REPORT NO. DECO-12-2191

REVISION 3

**ENRICO FERMI ATOMIC POWER PLANT  
UNIT NO. 2  
EVALUATION OF  
CONTAINMENT COATINGS**

Additional information and responses to NRC questions in accordance with Detroit Edison-NRC meeting on September 14, 1984.

FIGURE 1

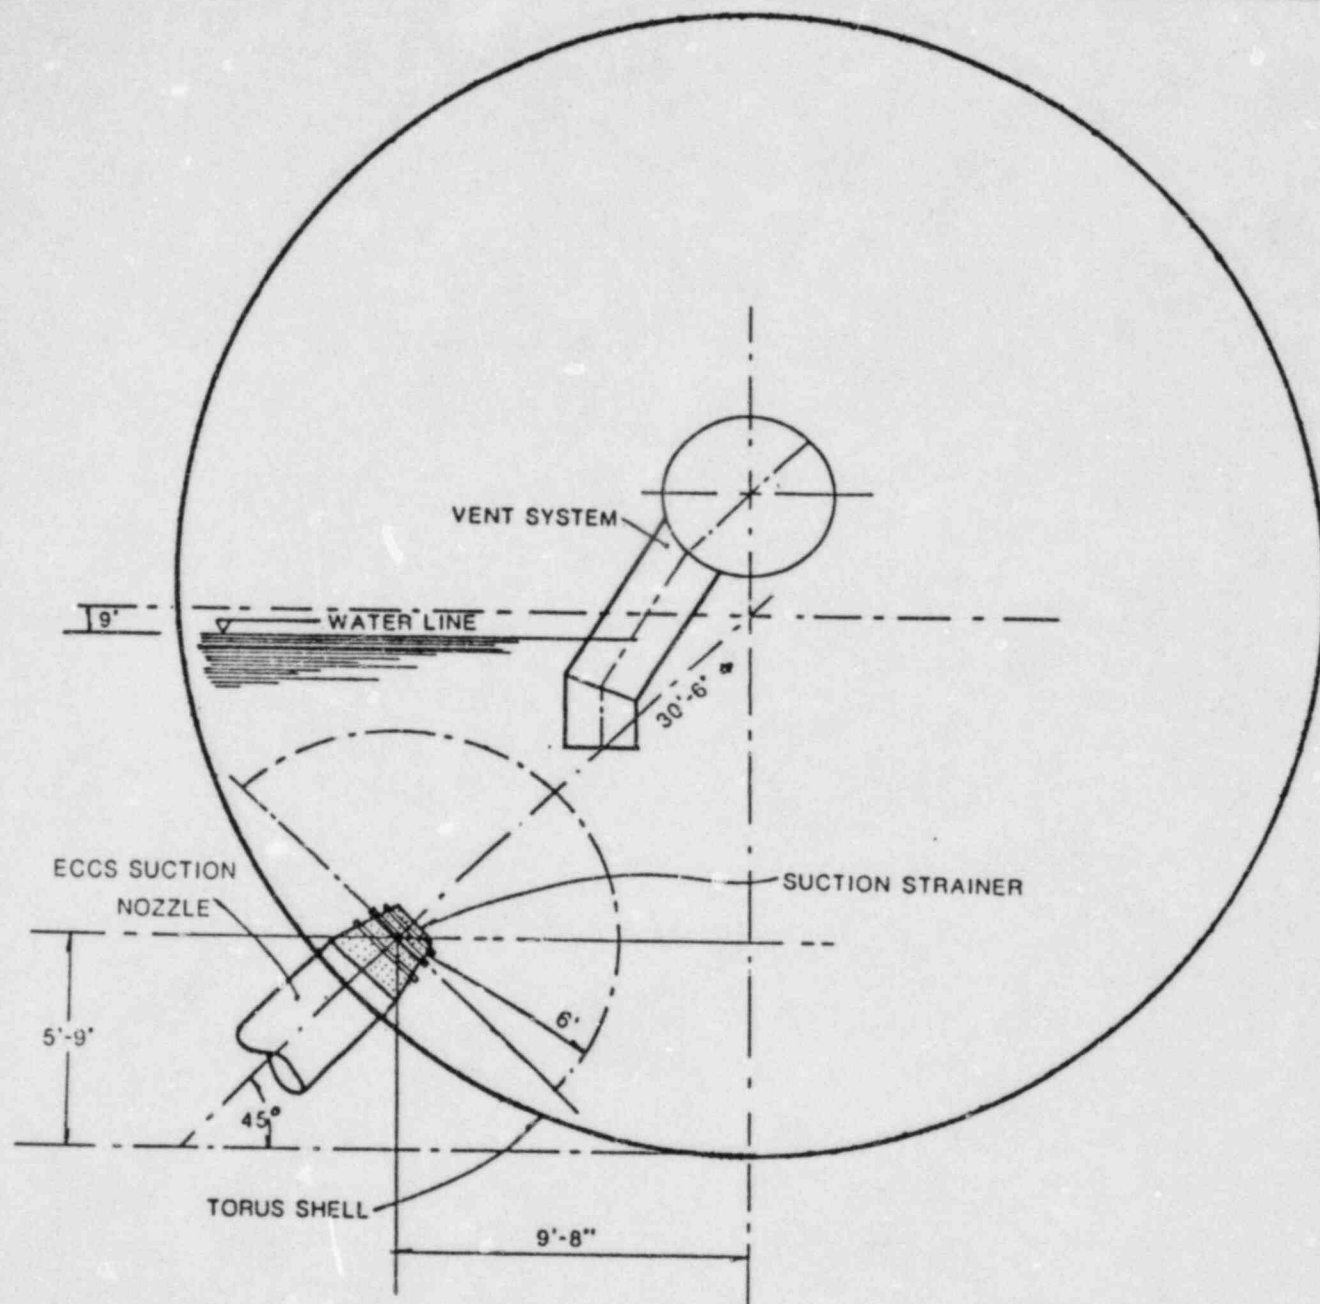
Average water velocities within the torus following the initial transient are below 0.25 ft/sec, but approach 0.3 ft/sec within a 4 foot hemisphere of the largest suction strainers at maximum RHR pump capacity. Refer to Figure 1 for the dimension and arrangement within the torus. The maximum surface velocity at the strainer surface was calculated to be 2.5 ft/sec. The strainer intakes are located 9'-8" from the center of the torus and 5'-9" above dead bottom. For these pool velocities hydroxide type particles are therefore not postulated to reach the strainers in a realistic situation.
